L-98-16  
Attachment 3

PROPOSED LICENSE AMENDMENTS FOR  
ADMINISTRATIVE CHANGES TO FACILITY OPERATING LICENSES  
AND TECHNICAL SPECIFICATIONS

PROPOSED FACILITY OPERATING LICENSE PAGES DPR-31

PROPOSED TECHNICAL SPECIFICATIONS PAGES

FIGURE 5.1-2 PLANT AREA MAP

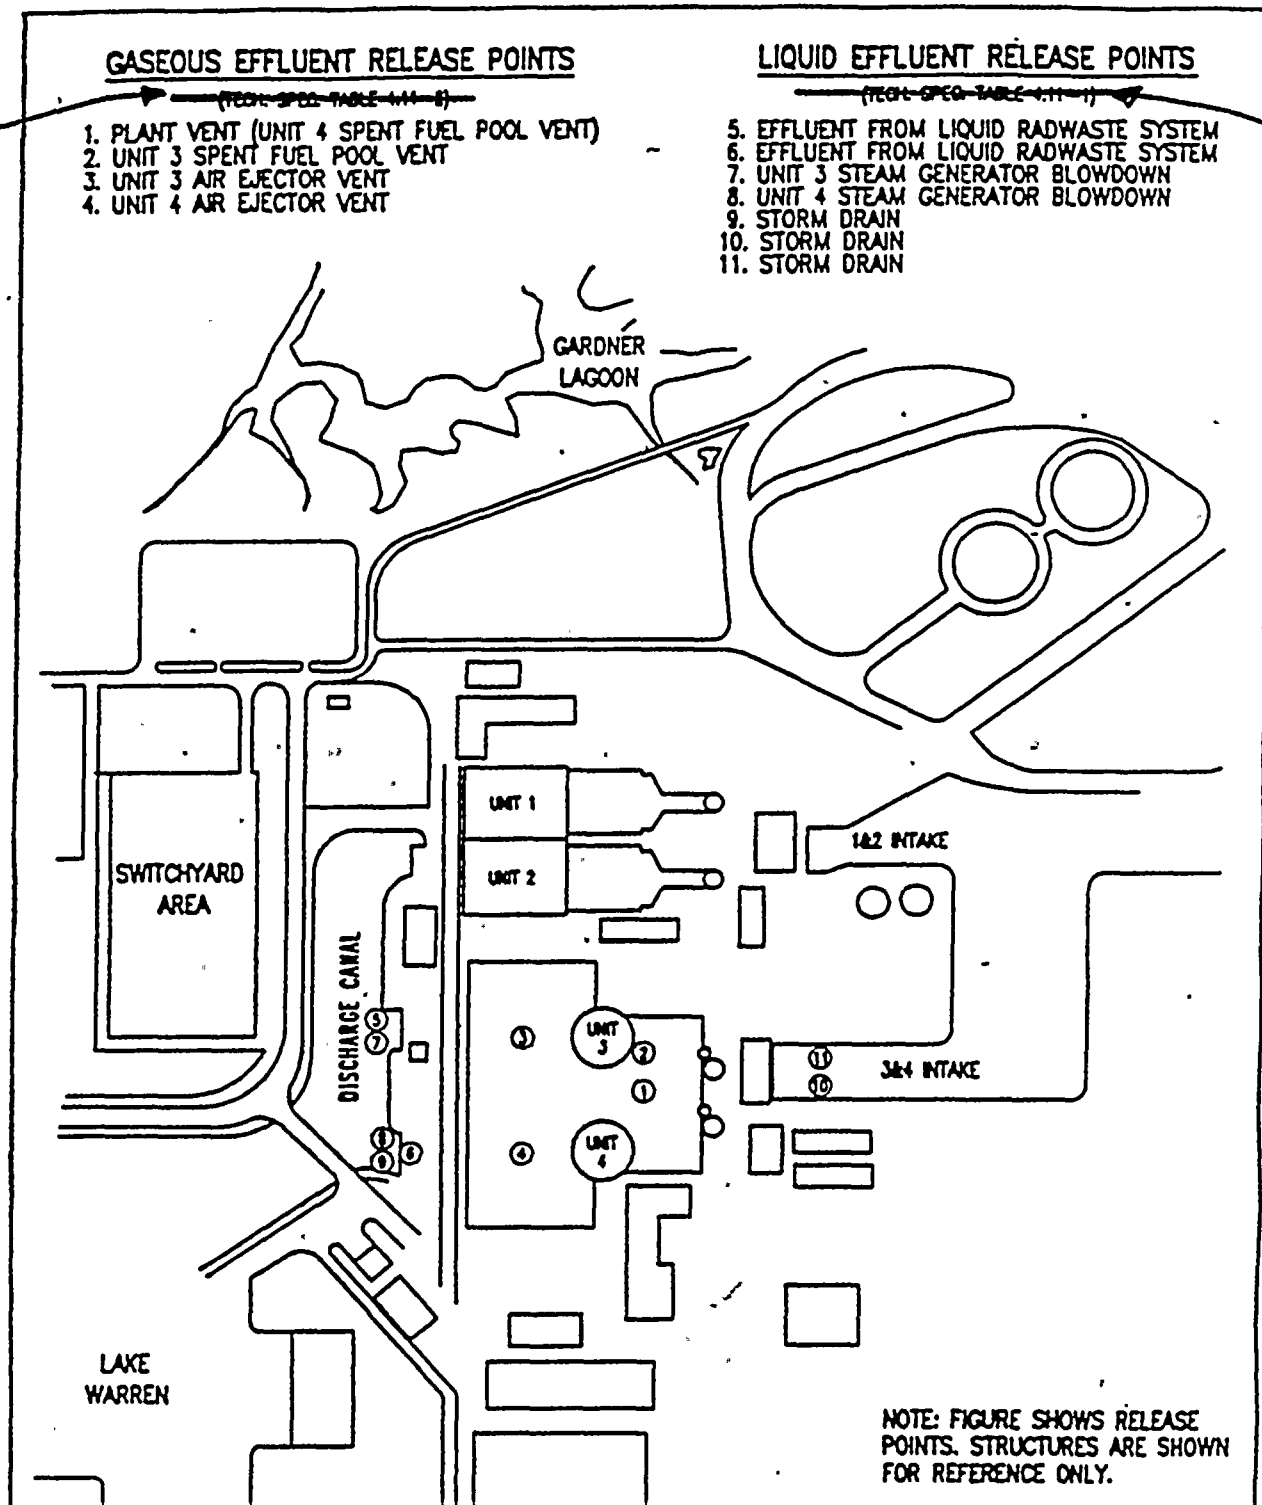
DELETE

DELETE
